HISTORIC AND DESIGN REVIEW COMMISSION

HDRC CASE NO: 2017-334
ADDRESS: 621 CENTER ST
LEGAL DESCRIPTION: NCB 584 BLK E1/2 7 LOT 12
ZONING: RM-4, H
CITY COUNCIL DIST.: 2
DISTRICT: Dignowity Hill Historic District
APPLICANT: Felix Ziga/Ziga Architecture Studio
OWNER: Henneke Financial Group
TYPE OF WORK: New Construction
REQUEST:

The applicant is requesting conceptual approval for approval to construct a two story, single family residential structure and a rear carport.

PROPOSED EXTERIOR ELEVATIONS

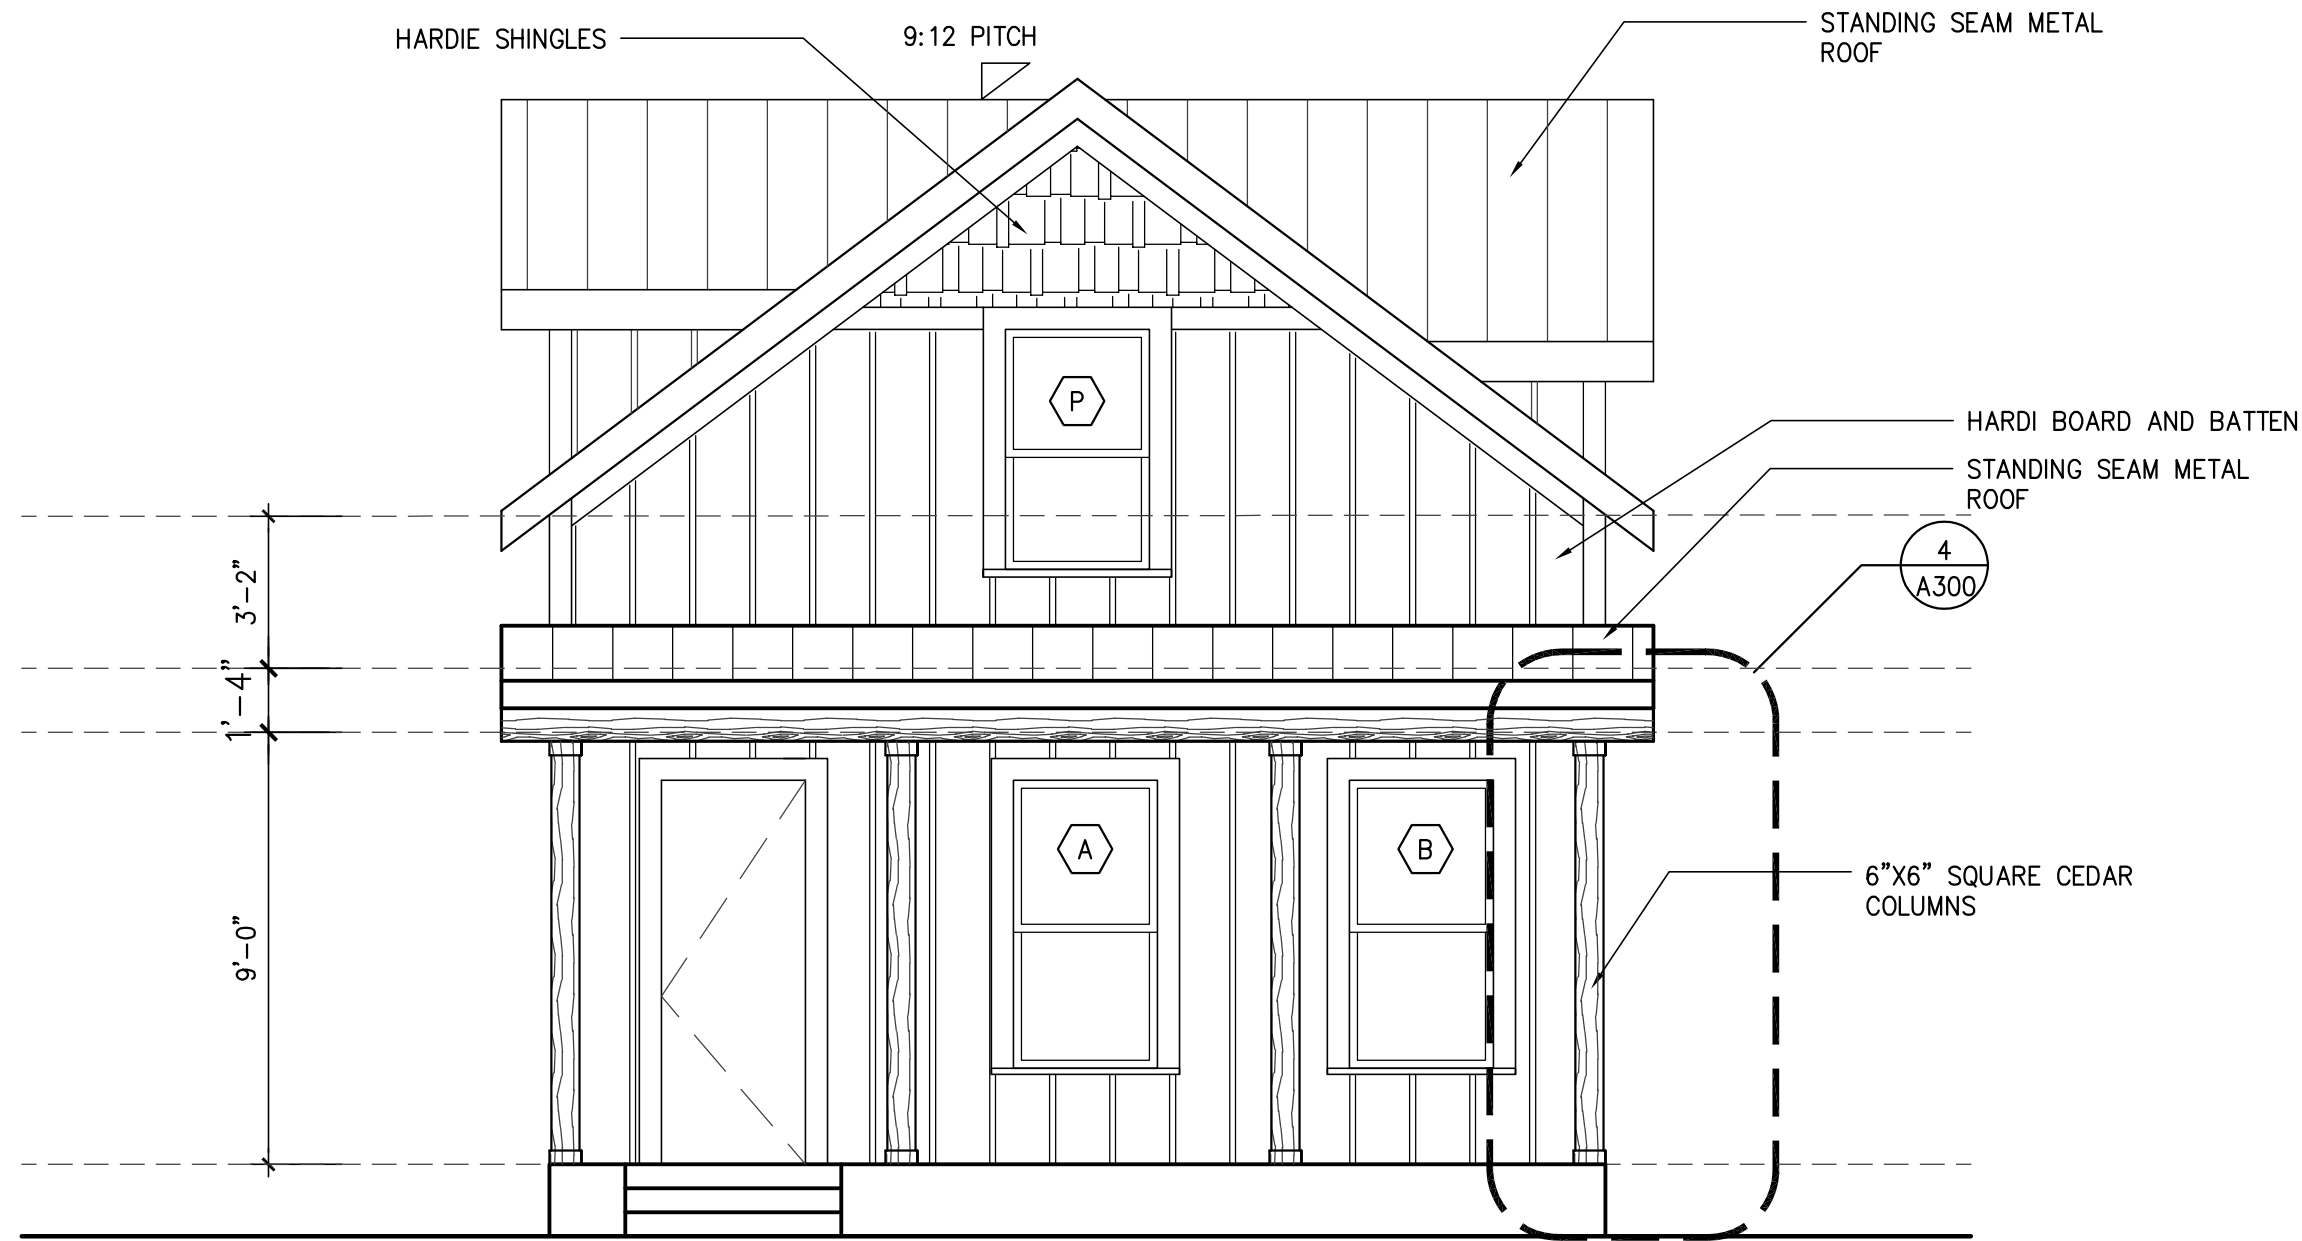
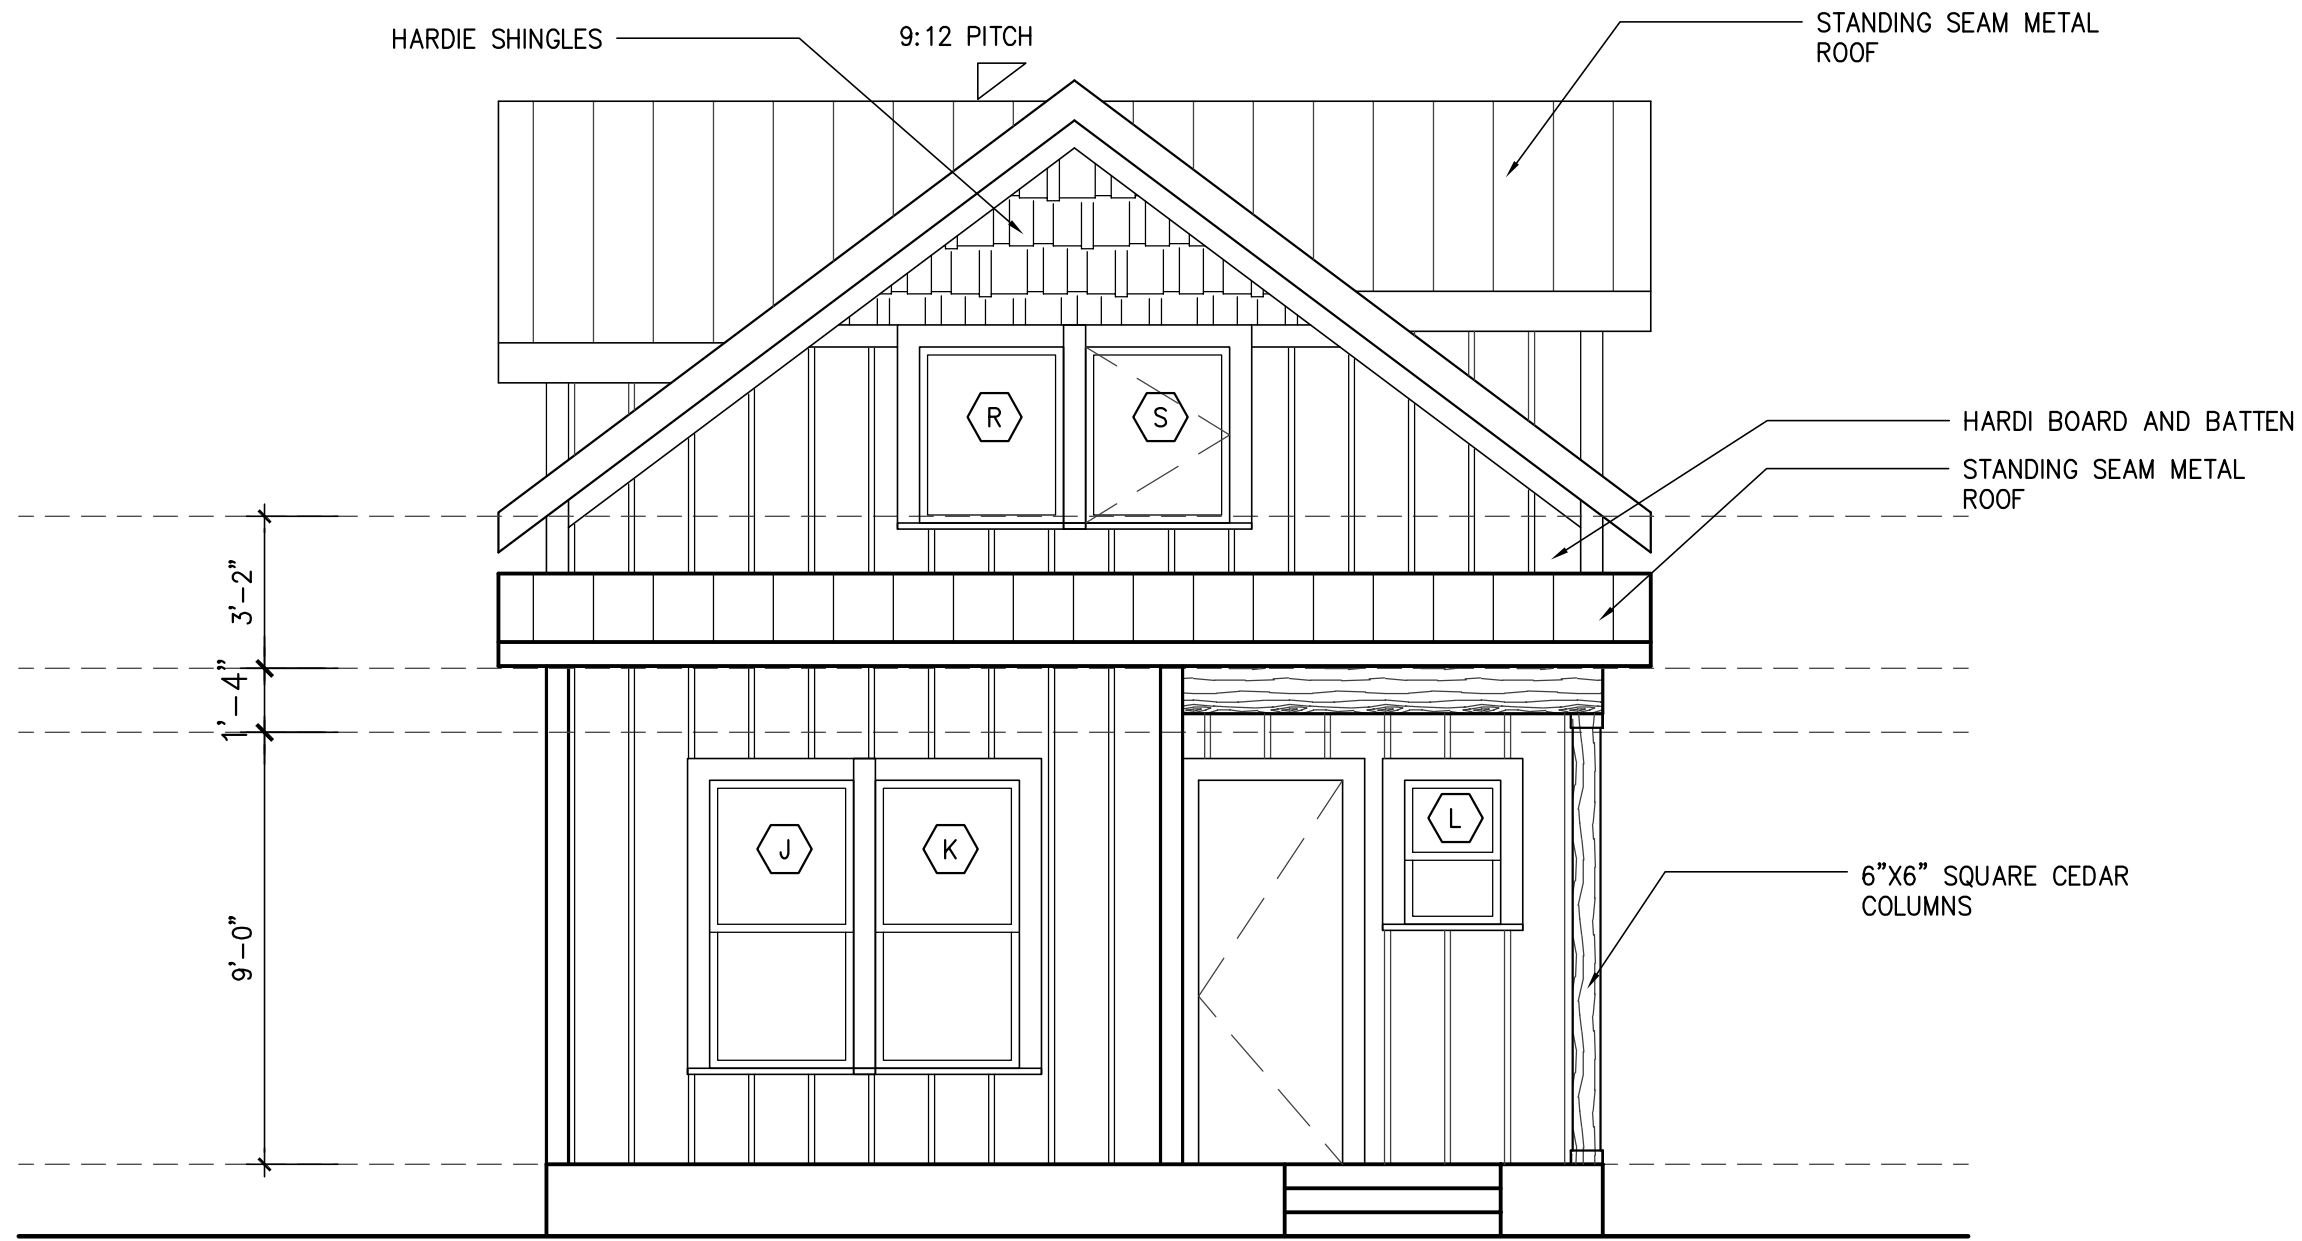
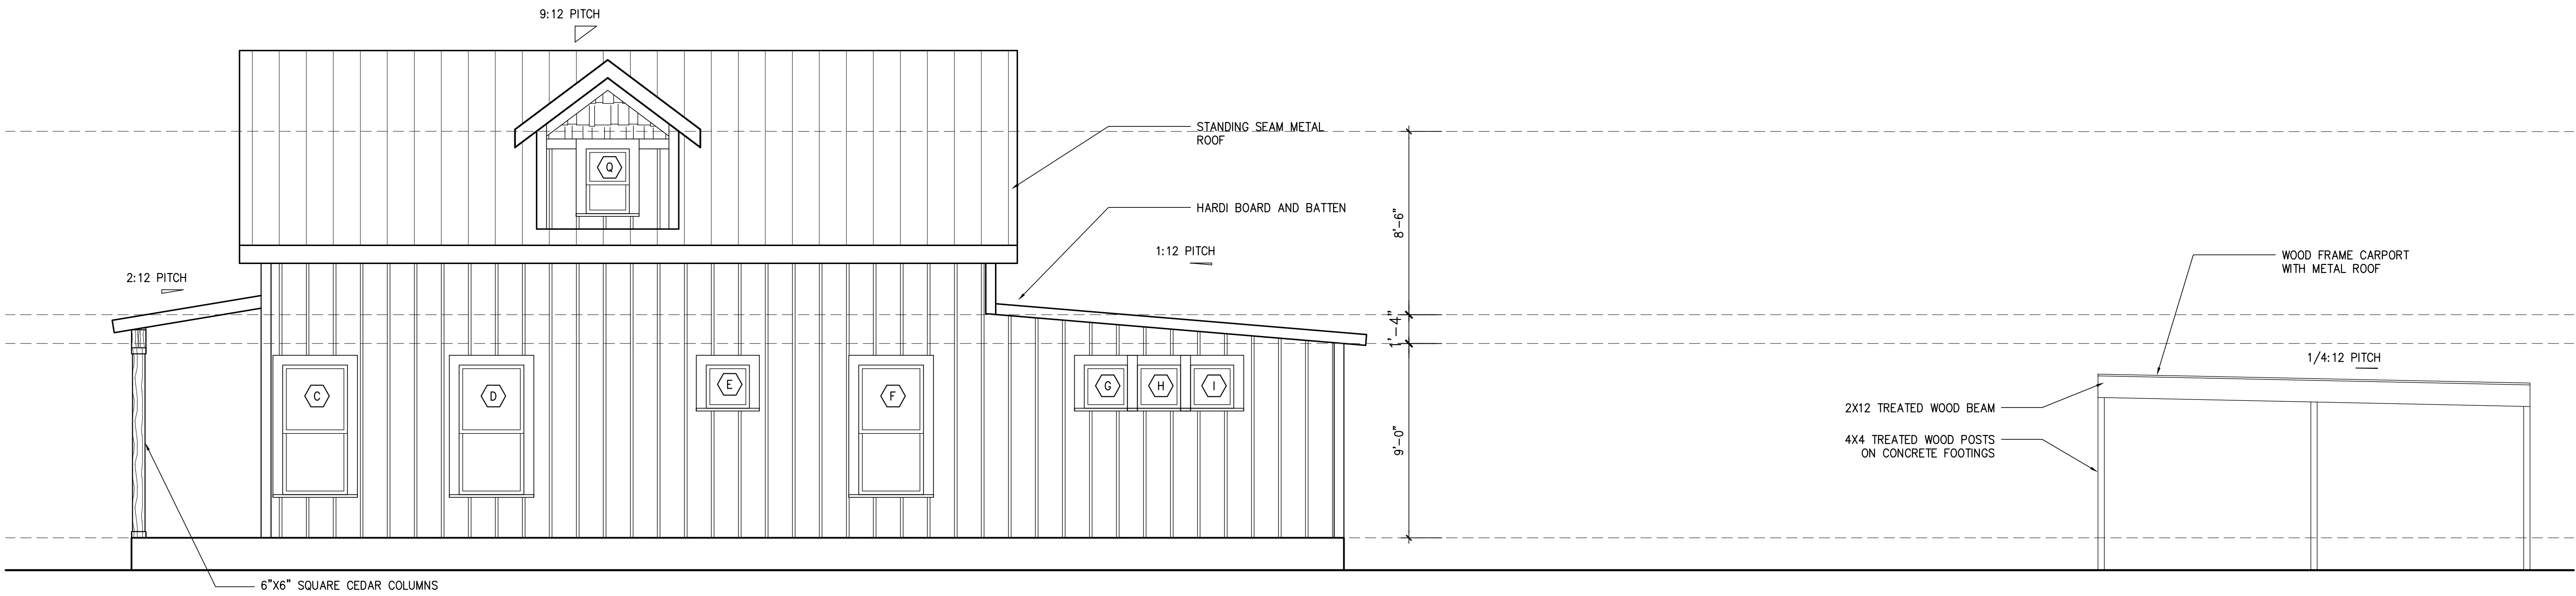
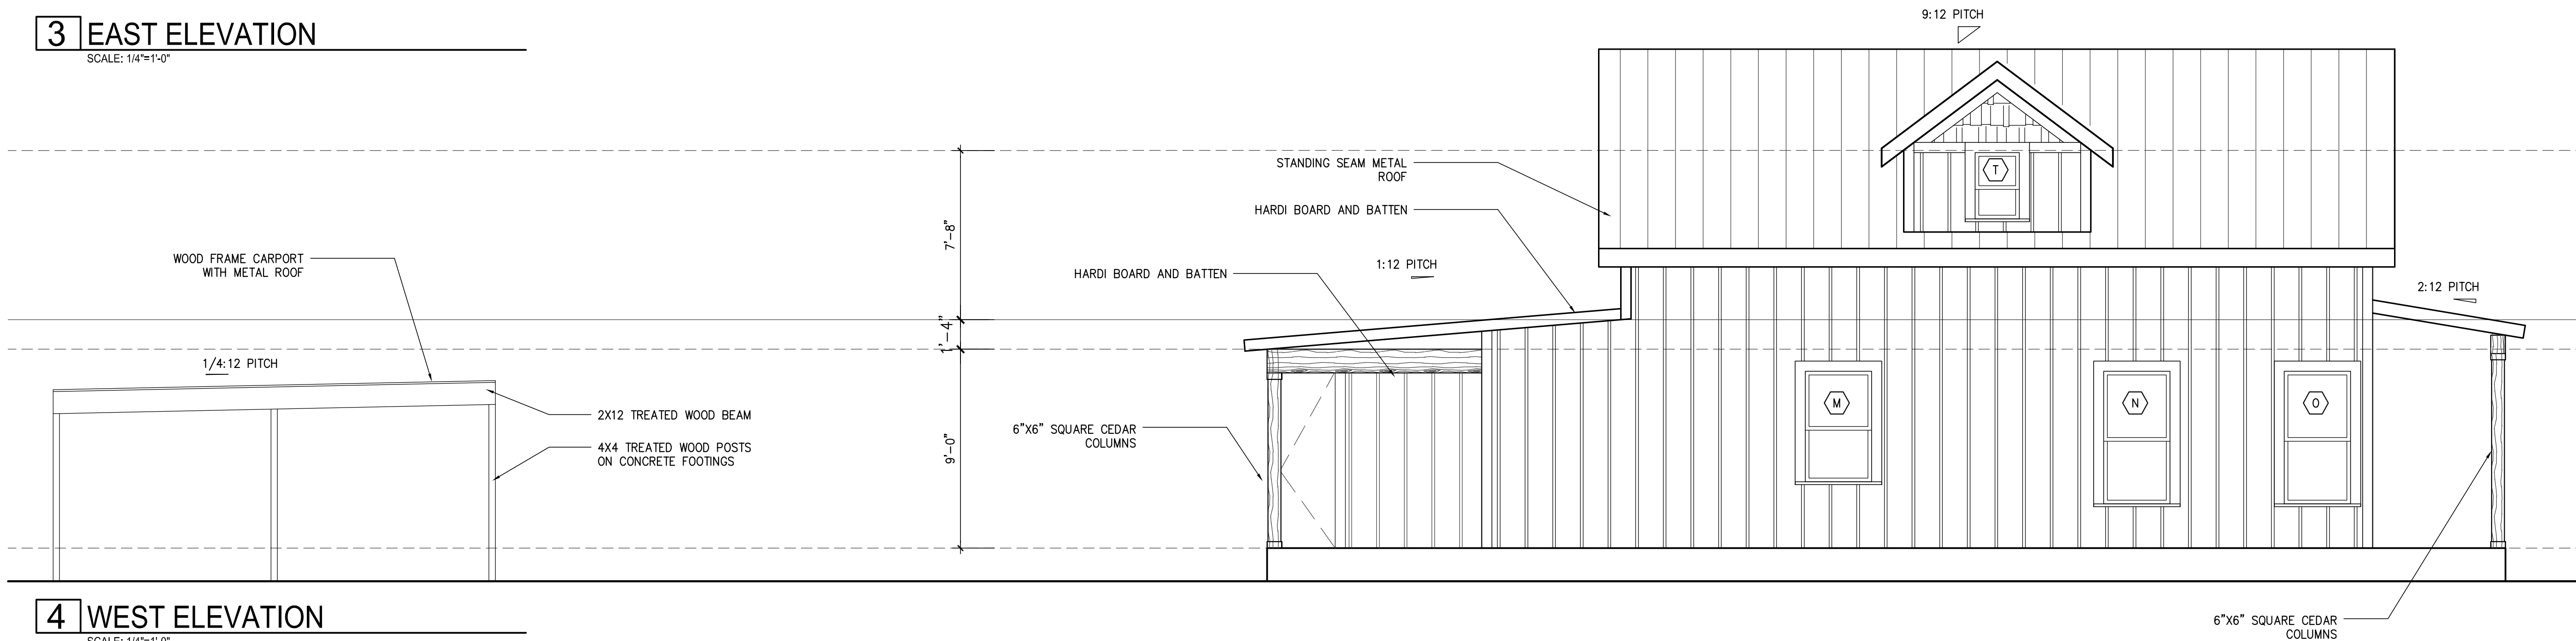
- iii. That additional massing be added to the porch roof, which is currently designed as a shed roof to add massing and depth to the front façade. *The applicant has increased the header height and increased the roof pitch of the shed roof.*

- iv. That the applicant reduce the massing of the proposed columns to six inches square and provide a detailed drawing when returning for final approval. *The applicant has reduced columns to six inches square.*

- m. **ARCHITECTURAL DETAILS** – New building should be designed to reflect their time while representing the historic context of the district. Additionally, architectural details should be complementary in nature and should not detract from nearby historic structures. Staff finds the proposed architectural details to be generally appropriate and consistent with the Guidelines. Since conceptual approval, the applicant has increased front porch header depth and the slope of the proposed shed roof. Staff finds the proposed design appropriate.

- n. **COLUMN DESIGN** – The applicant has proposed six inch square cedar columns. The proposed columns will feature trim at both the capital and base. Staff finds the proposed column design appropriate.

- i. That the siding should feature a smooth finish, an exposure of four inches, that the board and batten siding feature boards that are twelve (12) inches wide with battens that are 1 – ½” wide, that the standing seam metal roof feature panels that are 18 to 21 inches wide, seams are 1 to 2 inches in height, a crimped ridge seam or low profile ridge cap and a standard galvalume finish. A large profiled ridge cap shall not be used.
